Planning, Land Use and Mobility Committee Report DIR 2020-882-DRB-SPP-MSP

PLUM Meeting: November 19, 2020 (First presentation)

Project: Application for Director's Determination of Project Permit Compliance

for construction of a 3-story, 2,986 SF Single Family Residence in the Girard Tract and the outer core of the Mulholland Scenic Parkway

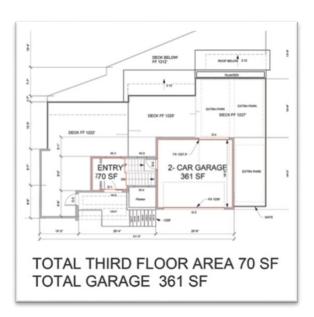
City Planning Document Information System does not provide the hillside slope analysis. At this time, we do not know if the project meets the allowable floor area for the site.

setback along the right-of-way, and the minimum 7' north side-yard setback required for buildings over 18' in height (1' added to side yard requirement of 5' minimum for each increment of 10' above height.) The south sideyard setback is 13'. The west backyard-setback is 77'4". The street was paved with gutters to less than full width and has retaining walls in the right-of-way needed to provide the parking lane. Looking at existing homes in the areas, a parking lane does not seem to be required on the project's side of the street to take it to full 40' width. The driveway is primarily in the right of way except for the 5' setback portion, presumably on grade or with partial compacted fill. Finished curbs exist along the roadway.

street. The structure height varies between 37' and 40' above finished grade at the flat roof. Due to the top floor being primarily rooftop decks, structural elements stay under the 25' envelope above natural grade according to the plans submitted.

The building meets the baseline Hillside Ordinance minimum required 5' front-yard

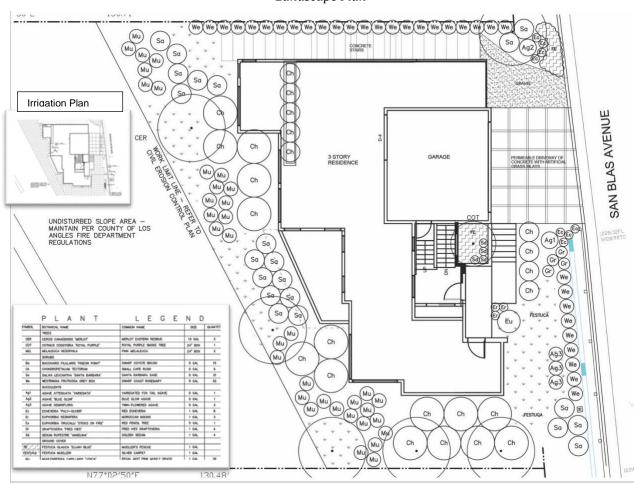
The illustration to the left indicates downspouts from roof barrels. Runoff and drainage from the building will be handled by downspouts and a French drain that direct rainfall into 530- and 850- gallon subsurface rain barrels anchored to a grade beam on the site. Overflow is directed to an existing diversion channel lower on the property. Permeable hillside coverings and planting on the top portion of the property will allow for even hillside absorption without resulting in major water run-off onto neighboring properties below.
